RUSH COUNTY SCHOOL CORPORATION

Rushville Elementary School Renovations

ADDENDUM NO. 1

Date of Issue: May 20th, 2024

1 MECHANICAL HVAC ROOF PLAN - UNIT C
1/8" = 1'-0"

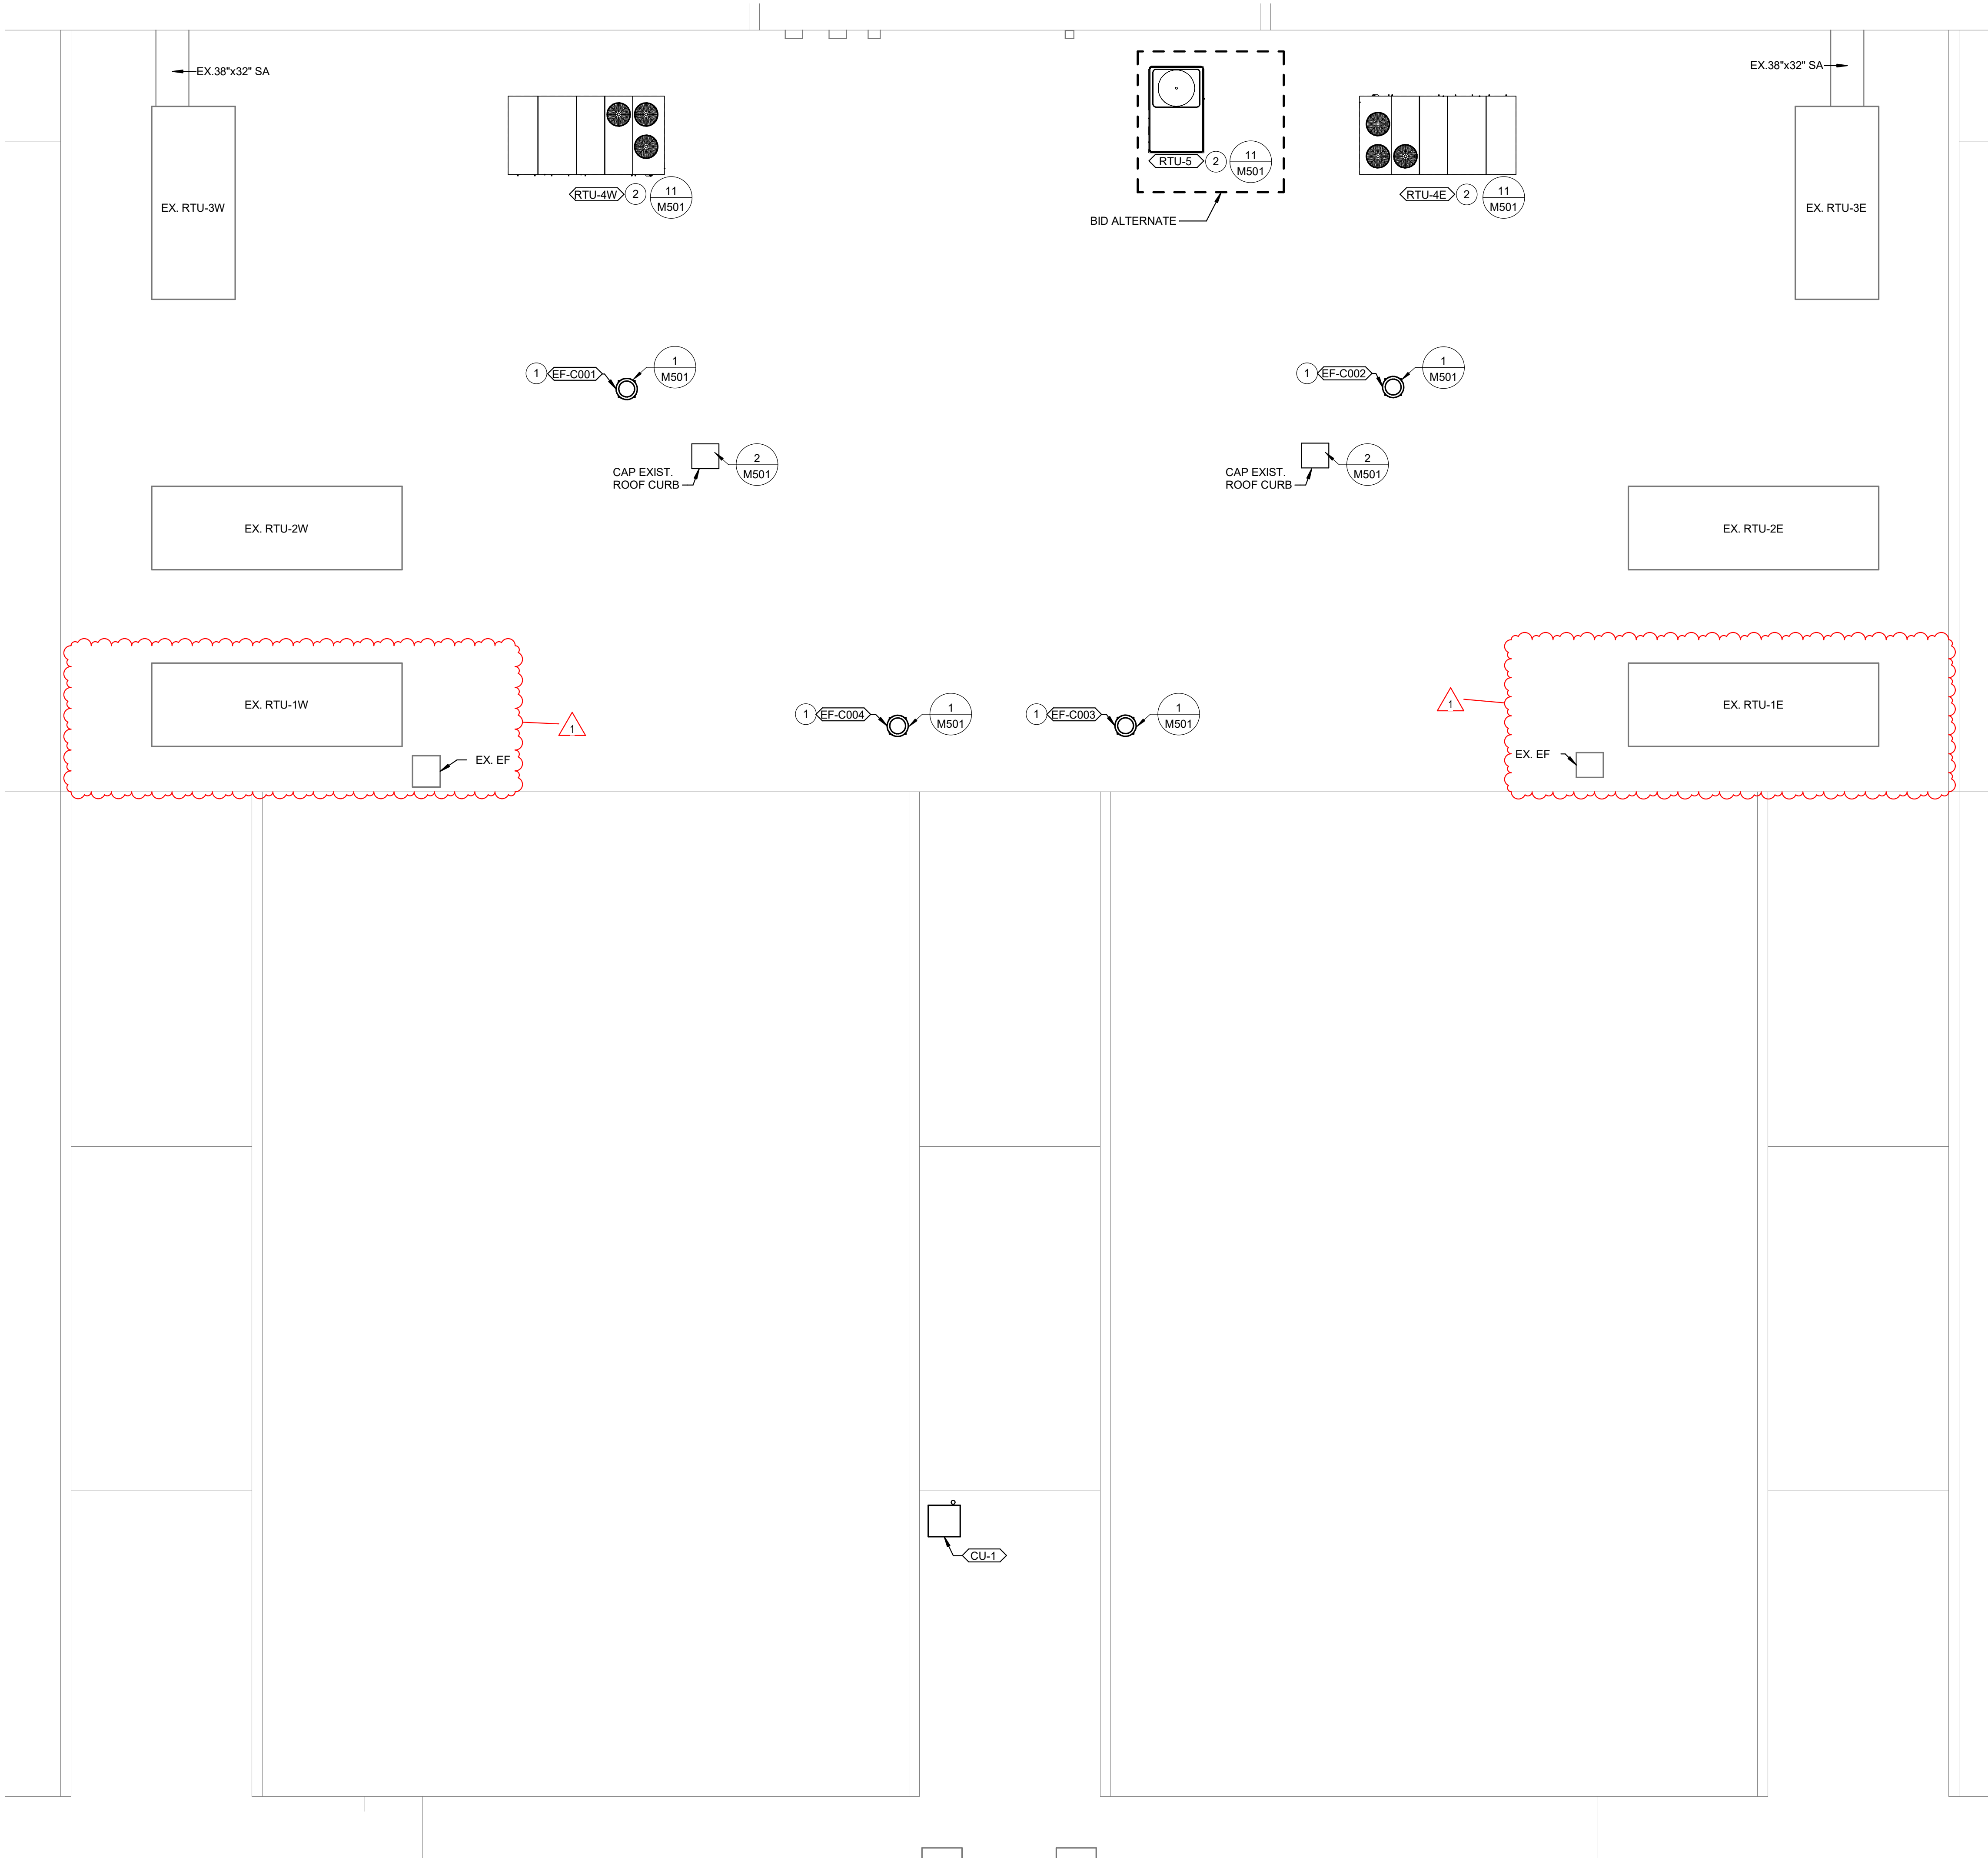
MECHANICAL ROOF PLAN NOTES
1. INSTALL NEW EF ON EXISTING CURB. PROVIDE CURB ADAPTER AS REQUIRED.
2. INSTALL NEW RTU ON NEW CURB.
